SAN ANTONIO WATER SYSTEM
CRESCENT PARK BOOSTER
STATION PROJECT
SAWS Job No. 12-6006
SAWS Solicitation No. B-12-043-CM

ADDENDUM NO.3
October 26, 2012

CRESCENT PARK BOOSTER STATION
SUCTION SIDE
5,000 GAL
HYDROPNEUMATIC
TANK LAYOUT
SAN ANTONIO, TEXAS

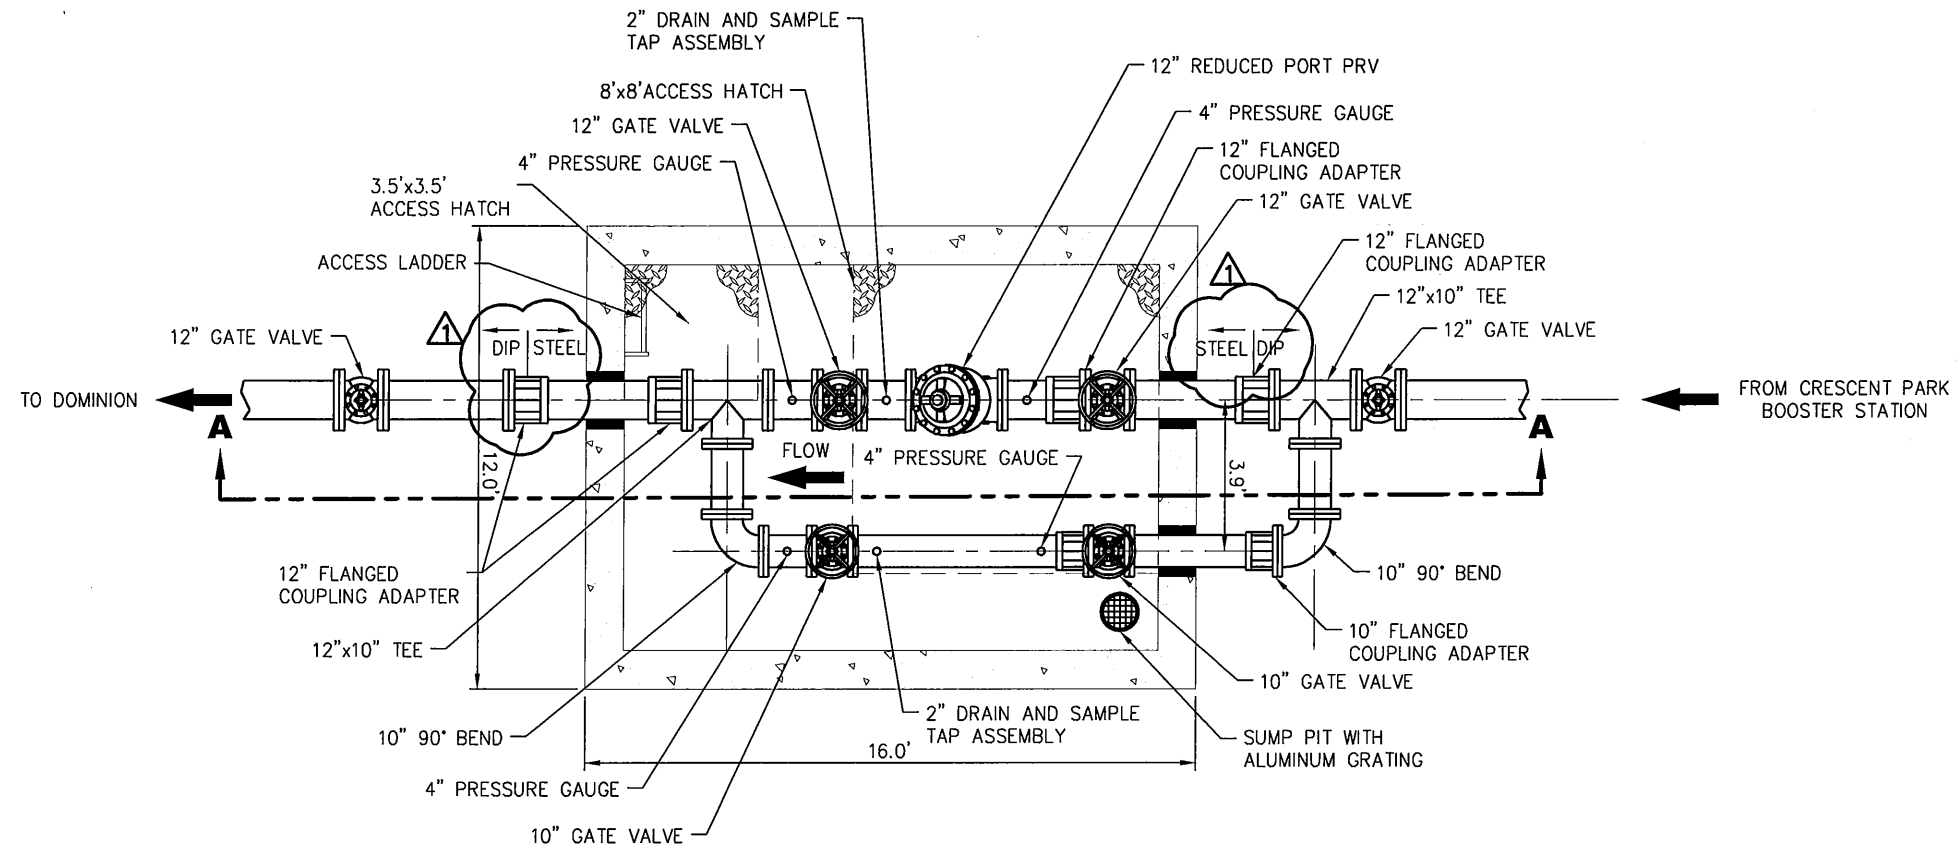
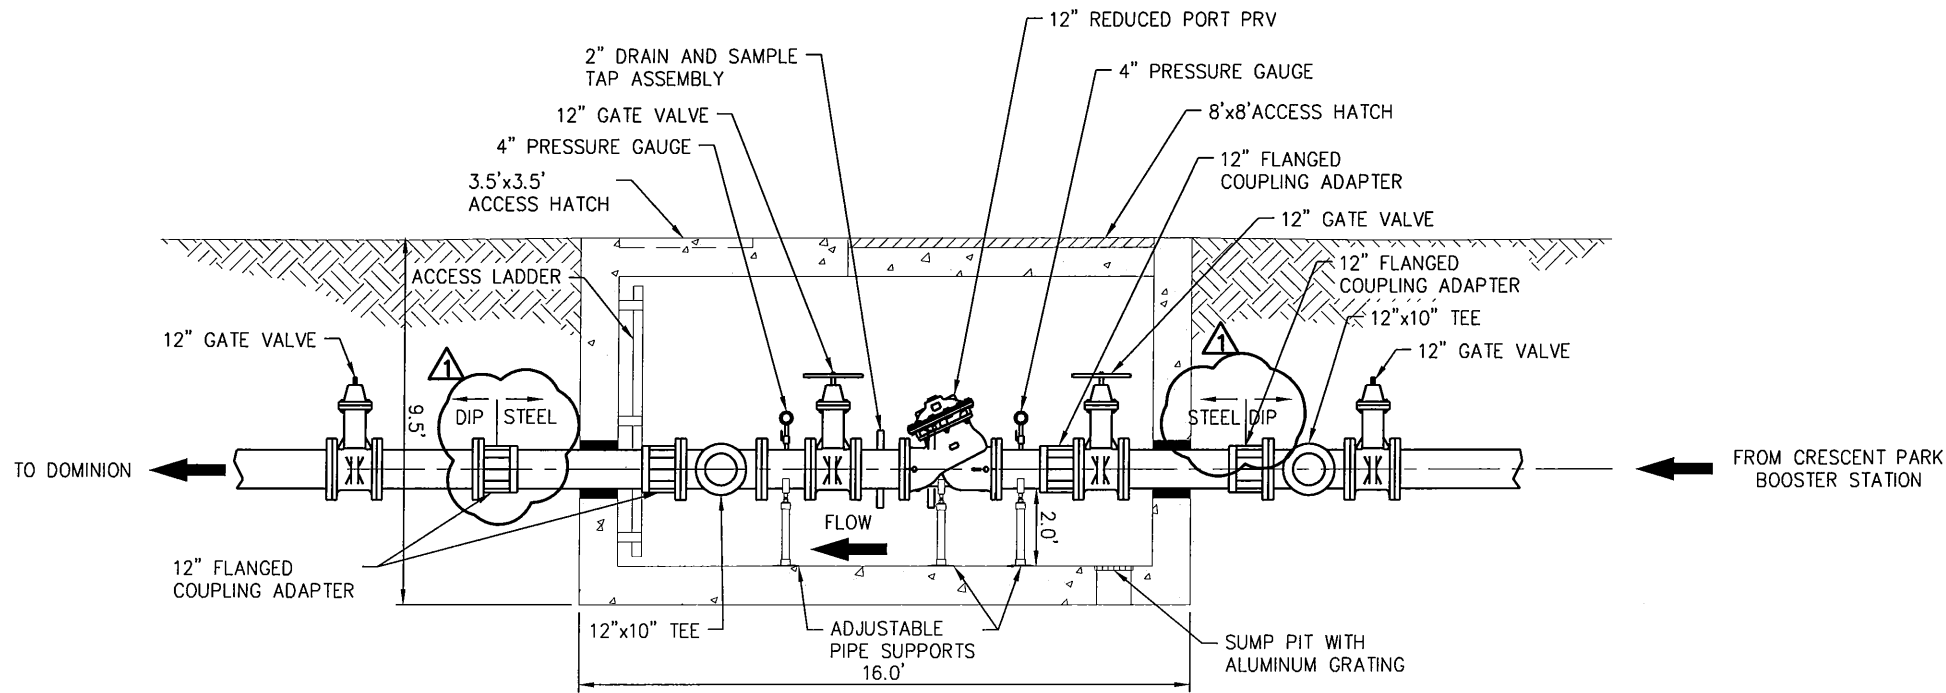
- A7:** *Item 11 on Sheet P2 indicates the air compressor pad locations. The sheet has been revised to clarify further. See Sheet P5 and P6 also for location of the air compressor pads. Size and type of piping for the air lines shall be per hydropneumatic tank system manufacturer’s recommendations.*

A27: *Refer to attached revised drawings P5 and P6 and revised Hydropneumatic Tank System Specification Section 15500 for Saddles, Inlets/Outlets and Manway requirements. Sight Glass Enclosure shall be located as shown on drawings.*

1/S1 OVERALL FOUNDATION LOCATION PLAN
 SCALE: 1/16" = 1'-0"

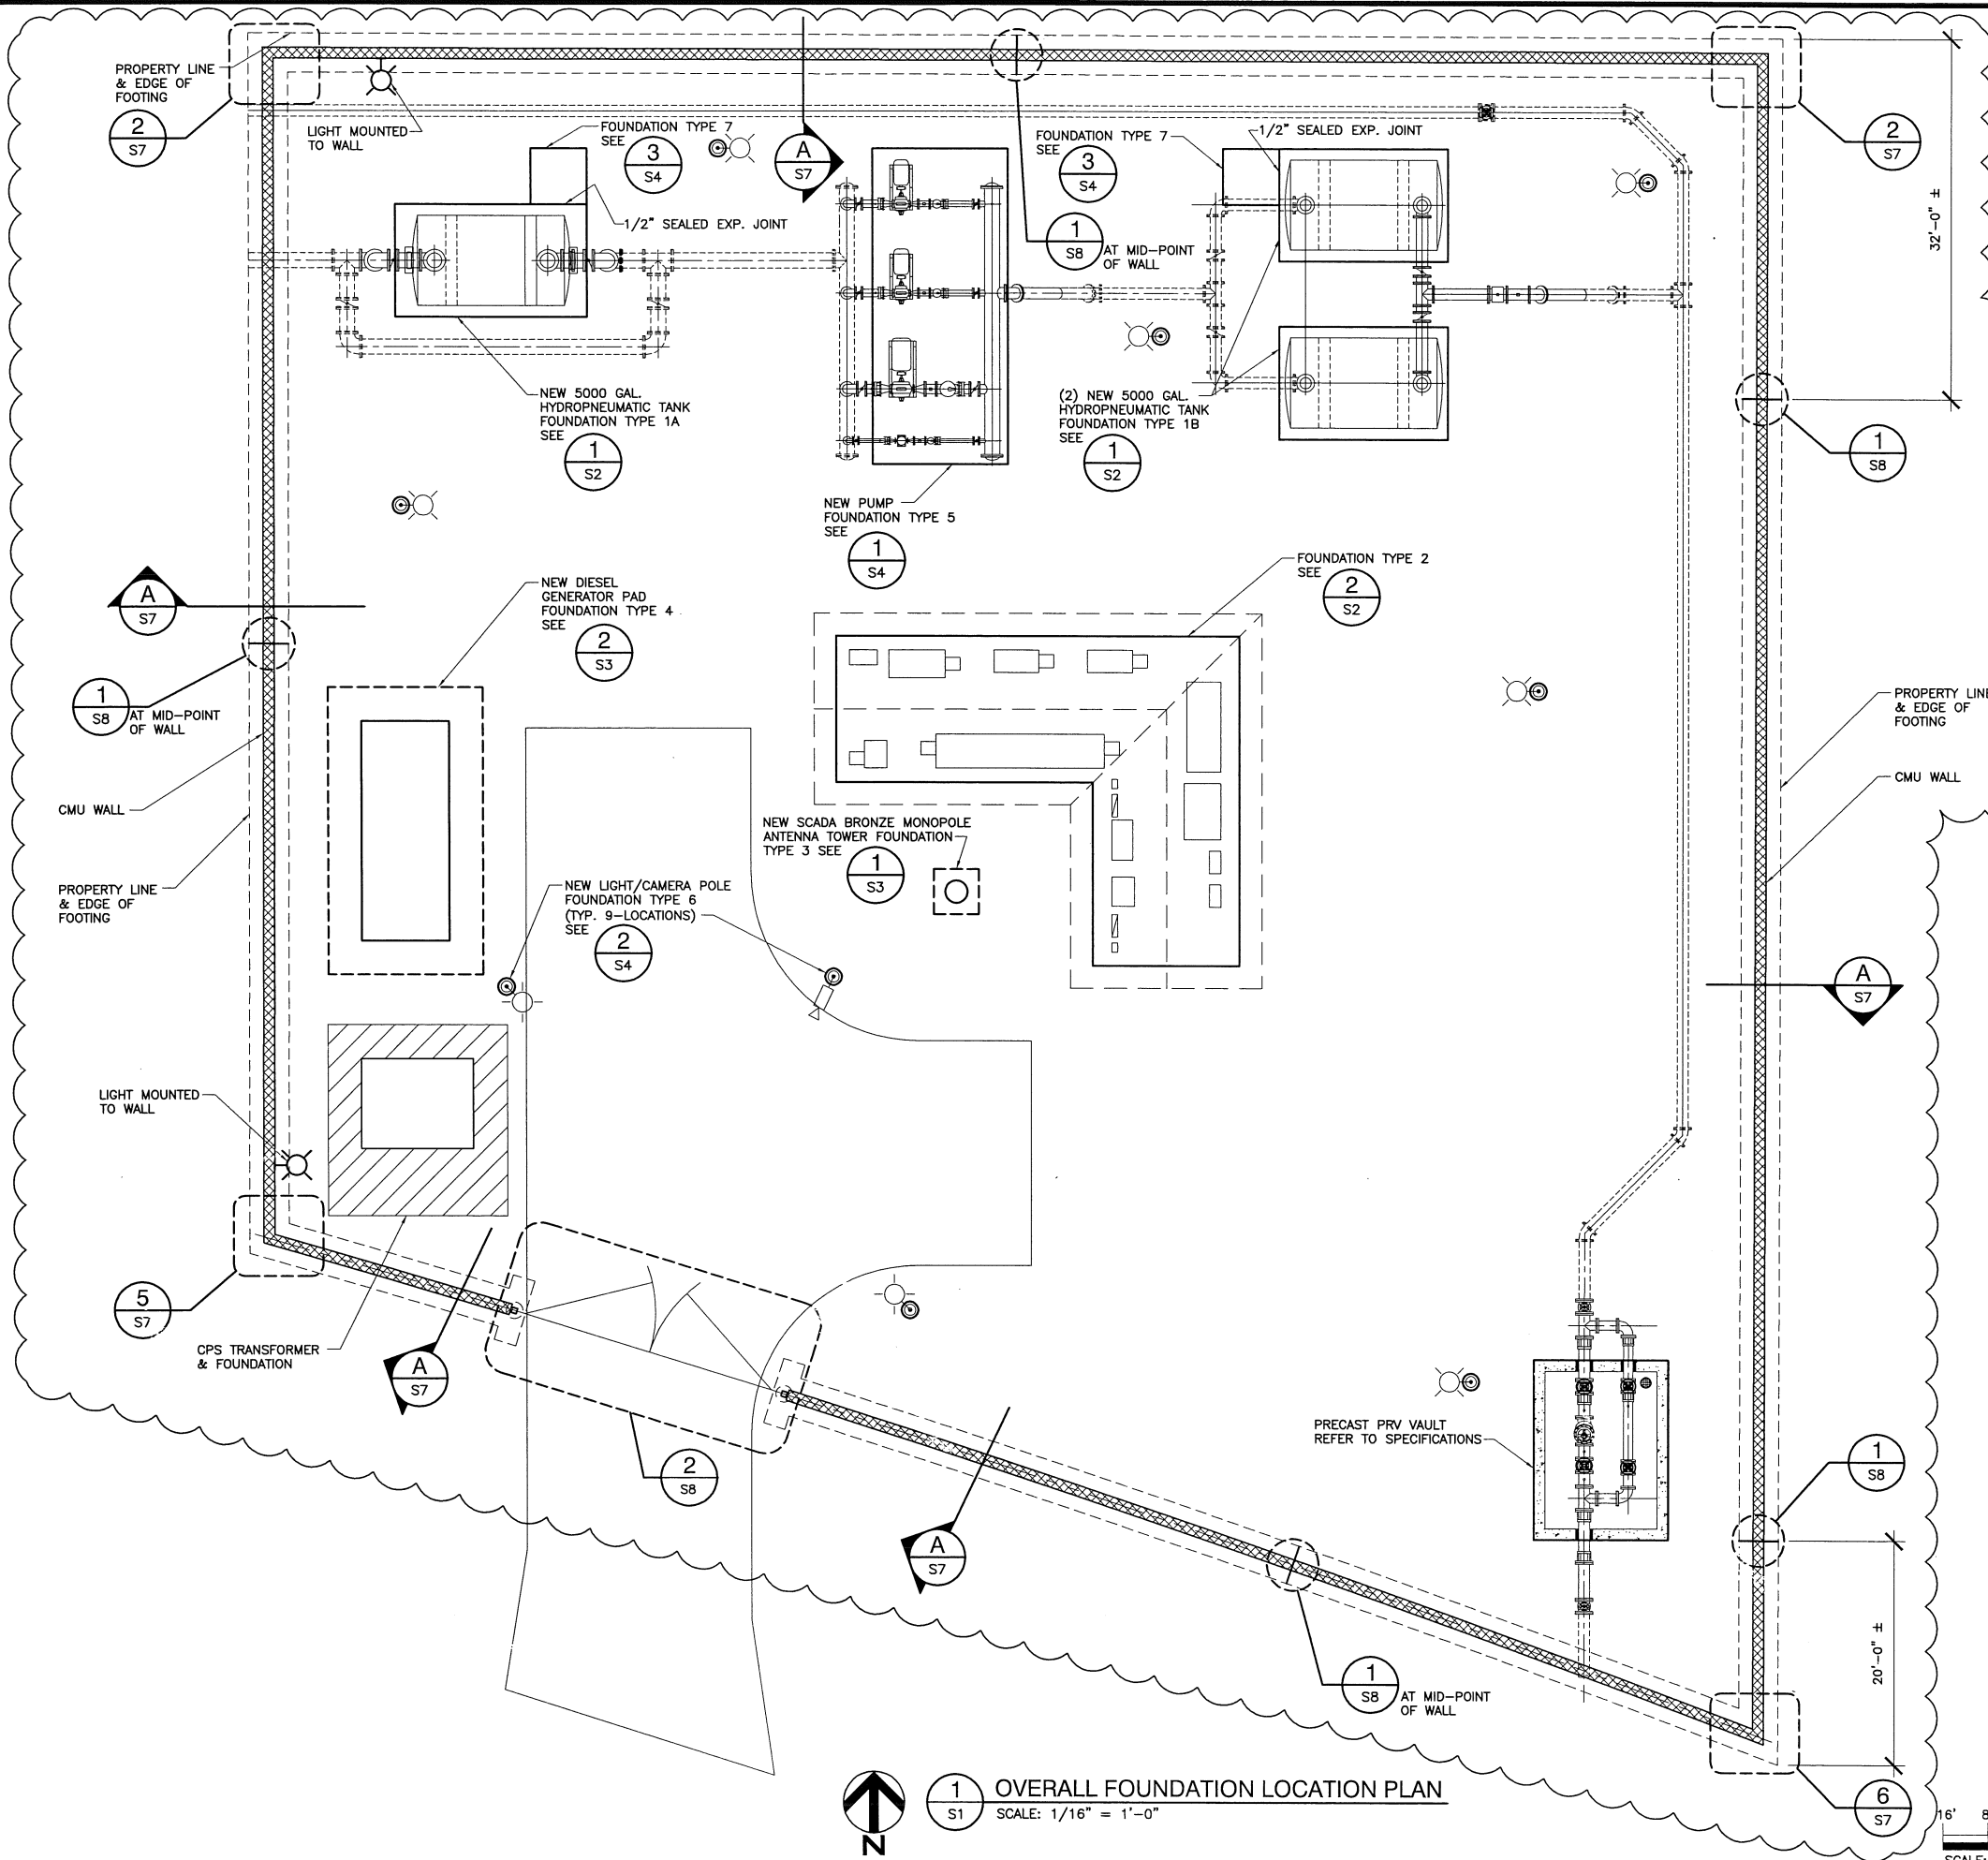
- A11: *The details for the wall have been included in this Addendum. See Attached Sheets S1, S7, and S8.*
- Q12: The bid form and the drawings call for a 10' security wall and a gate, but I can't find any other information or a specification on this wall. Can we get a specification and/or a detail drawing giving the contractors more information on this item?

- A18:** *The third condition in Section 15500.24(2)(C) is correct as written.*
- Q19: Please provide a detail for the security wall around the site.
- A19:** *The details for the wall have been included in this Addendum. See Attached Sheets S1, S7, and S8.*

CRESCENT PARK BOOSTER STATION
CMU WALL SECTIONS & DETAILS
SAN ANTONIO, TEXAS

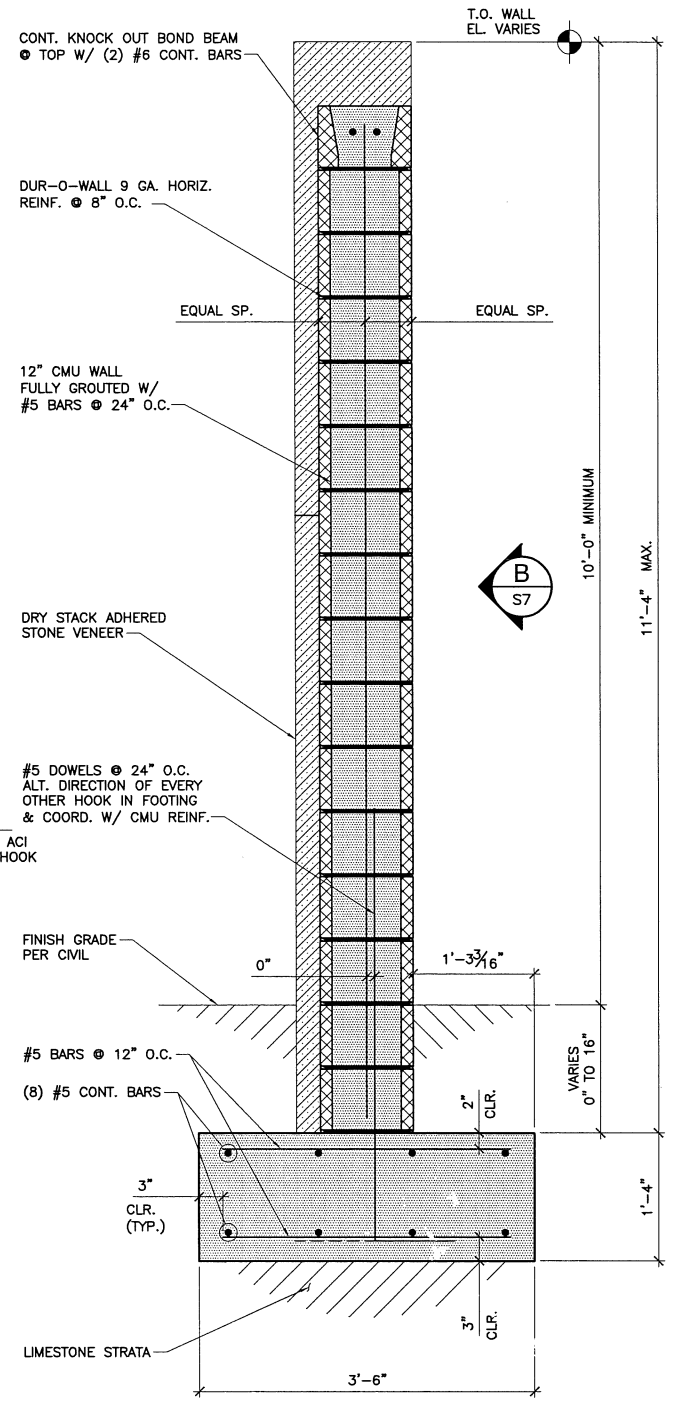
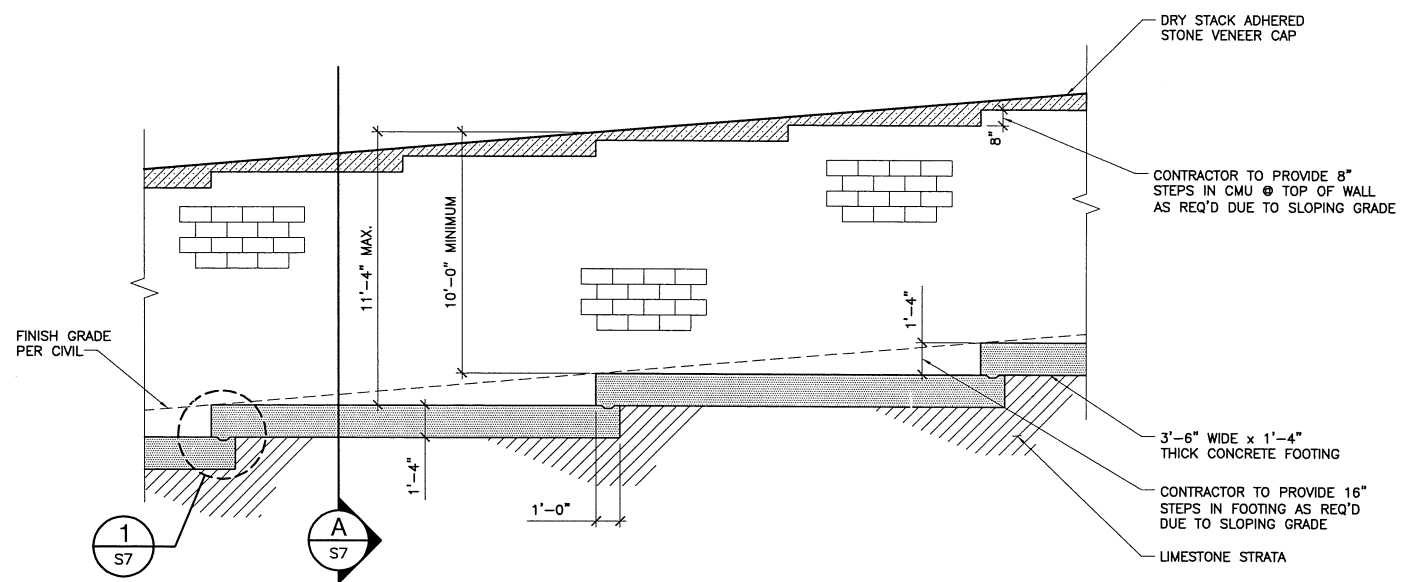
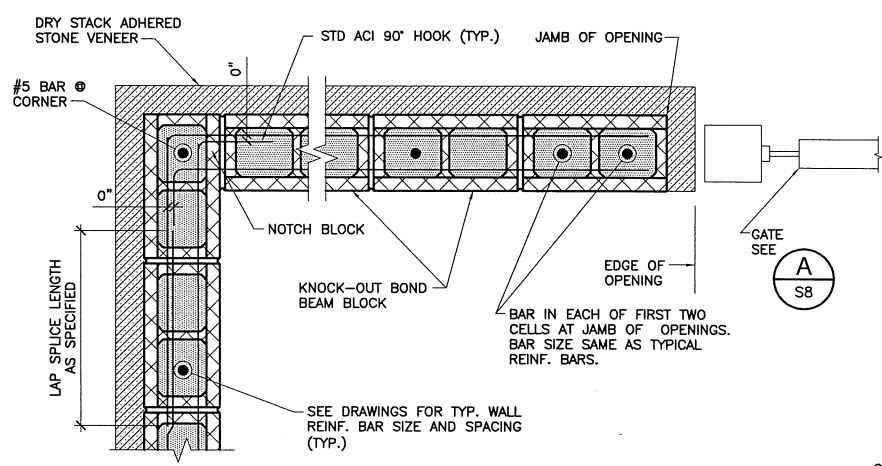
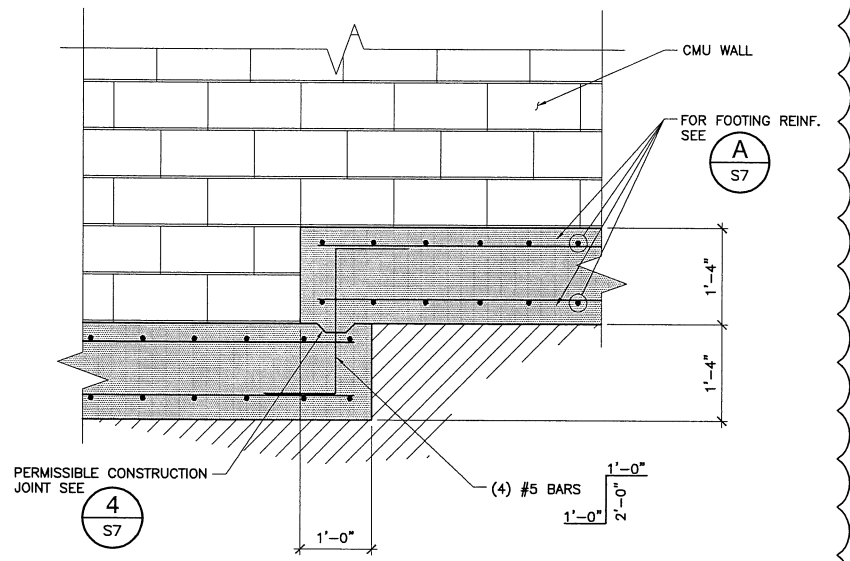
- SC-2.14 Proposed CMU/Masonry Wall. The dry stack adhered stone used for the proposed CMU/Masonry wall shown on Sheet S7 of the Plans shall match the ranges of colors, shapes, textures and sizes of the stones of the existing wall located at the northwest corner of the Dominion Drive and Crescent Park Intersection. The overall finished appearance of the proposed wall also shall match the existing wall located at the northwest corner of the Dominion Drive
